Engineering Review
 03/11/2021 2:18:44 PM
 dsdrice
 JeffRice@elpasoco.com
 (719) 520-7877
 EPC Planning & Community
 Development Department

PCD-ENGINEERING REVIEW COMMENTS
 IN BLUE BOXES WITH BLUE TEXT

PRELIMINARY SITE GRADING CONSTRUCTION PLANS
 FOR
SKYLINE AT LORSON RANCH

EARLY OVERLOT GRADING / EROSION CONTROL PLANS

Sediment Trap (ST)

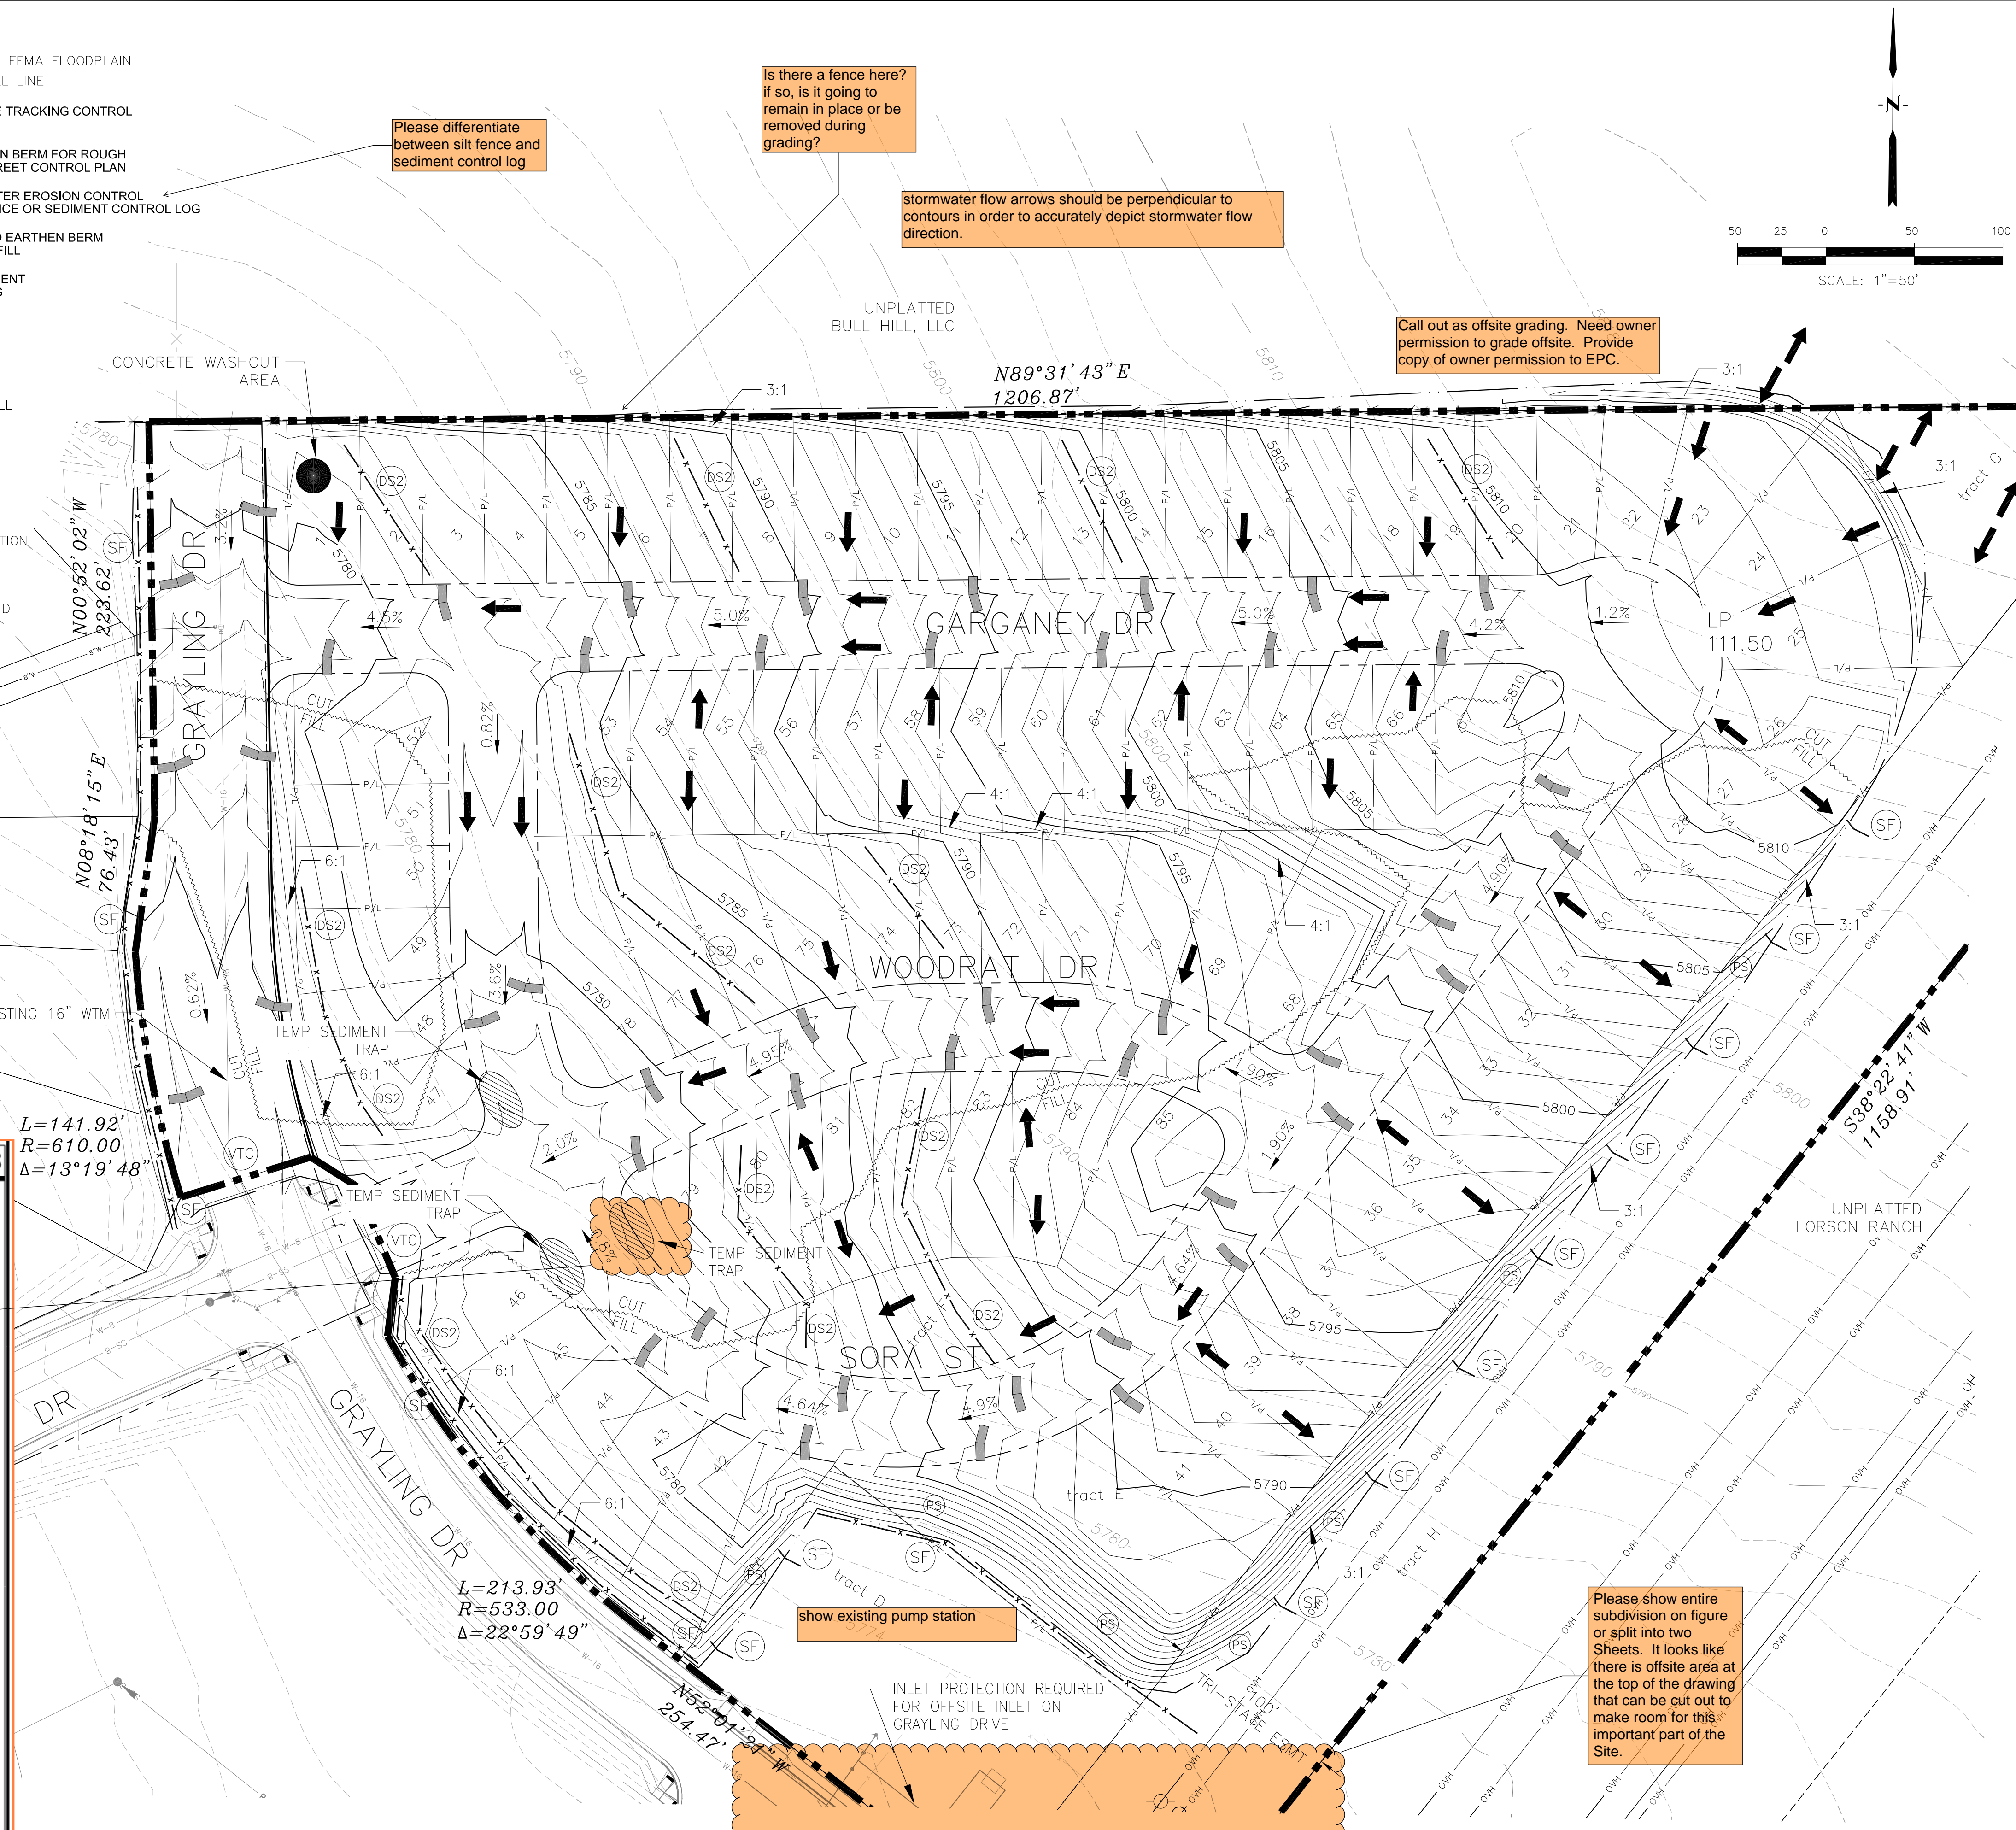
May need to include temporary drainage ditches to direct stormwater to sediment basins

Sediment traps are for drainage areas less than 1 acre. Please use sediment basins at the Site.

SKYLINE AT LORSON RANCH AND OVERLOT EARLY GRADING AND EROSION CONTROL PLAN

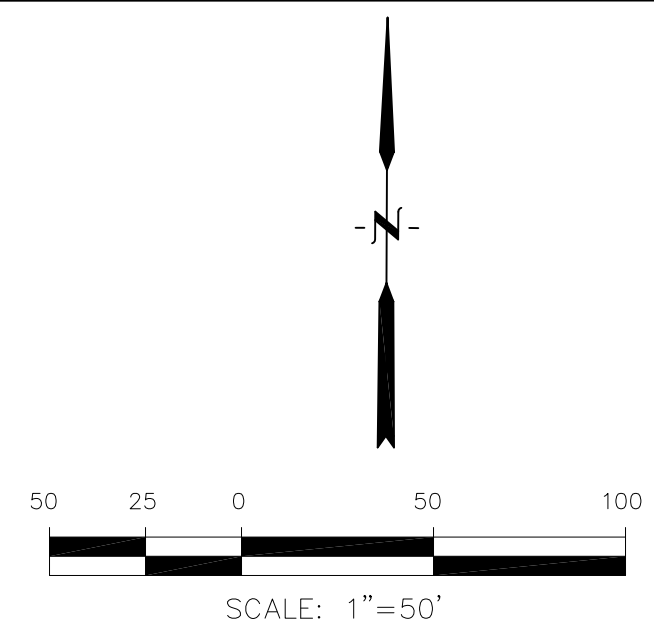
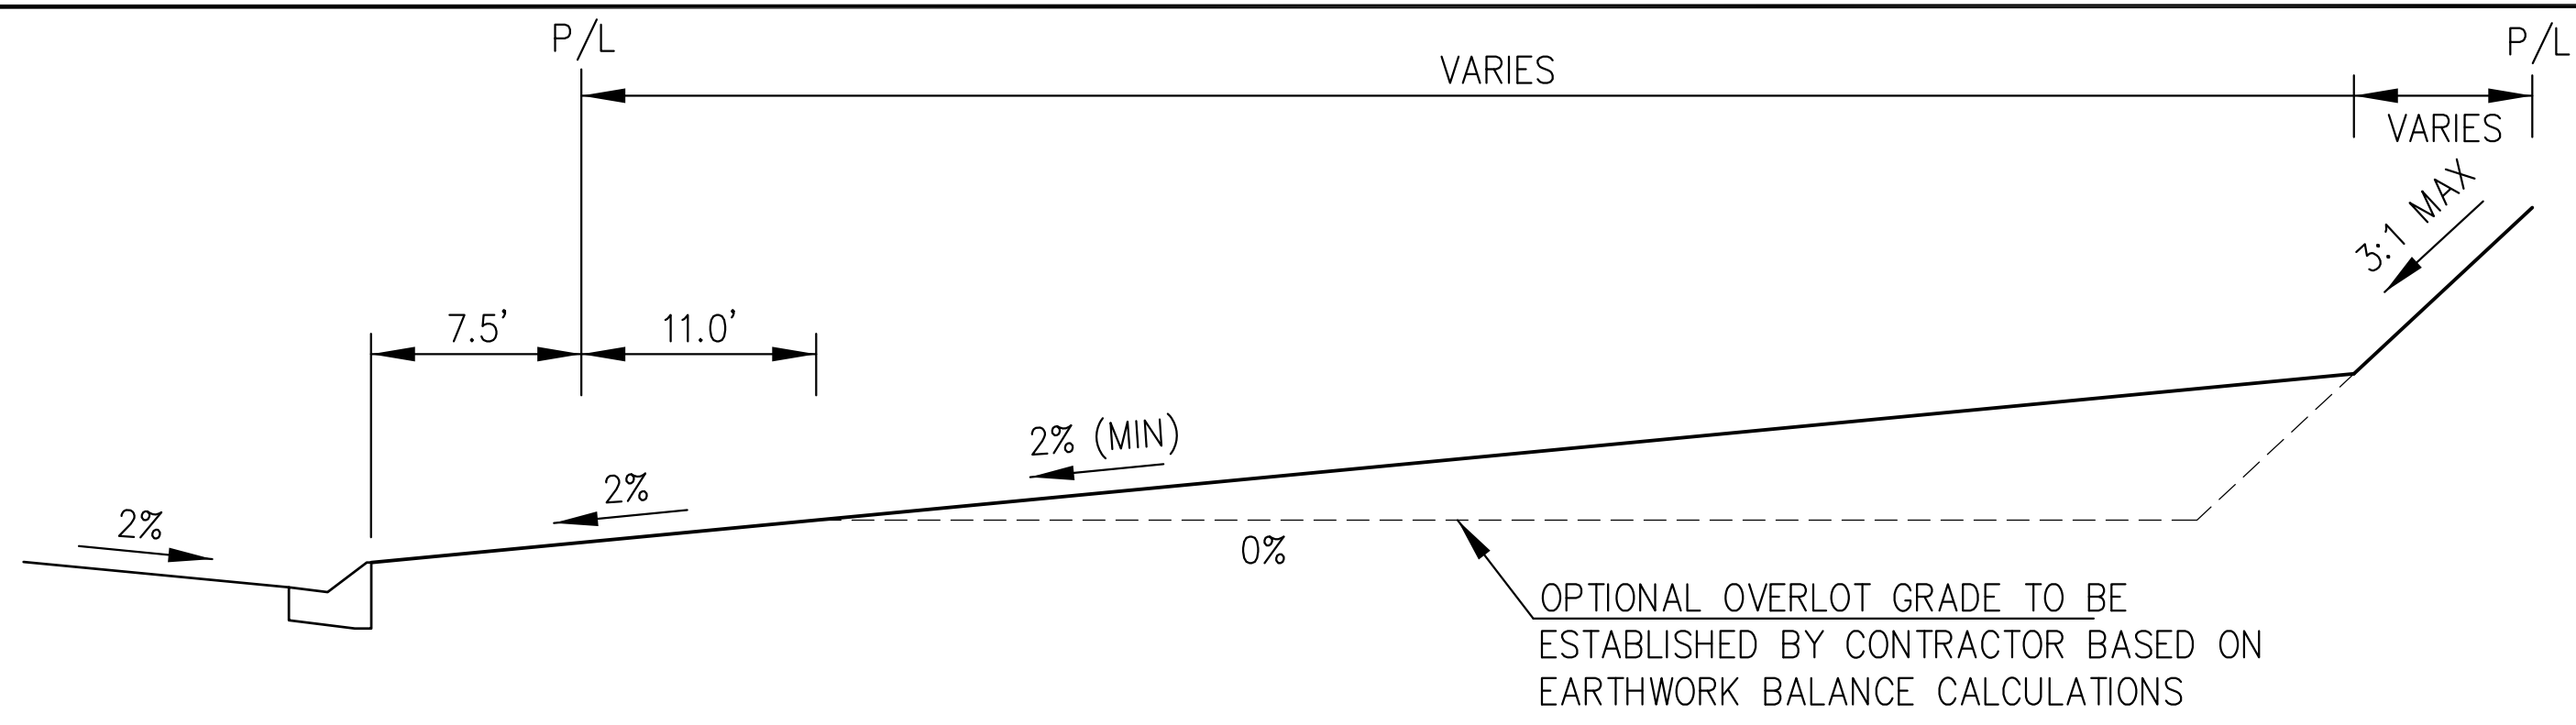
Is there a fence here? if so, is it going to remain in place or be removed during grading?

stormwater flow arrows should be perpendicular to contours in order to accurately depict stormwater flow direction.

Call out as offsite grading. Need owner permission to grade offsite. Provide copy of owner permission to EPC.

show existing pump station

Please show entire subdivision on figure or split into two sheets. It looks like there is offsite area at the top of the drawing that can be cut out to make room for this important part of the Site.
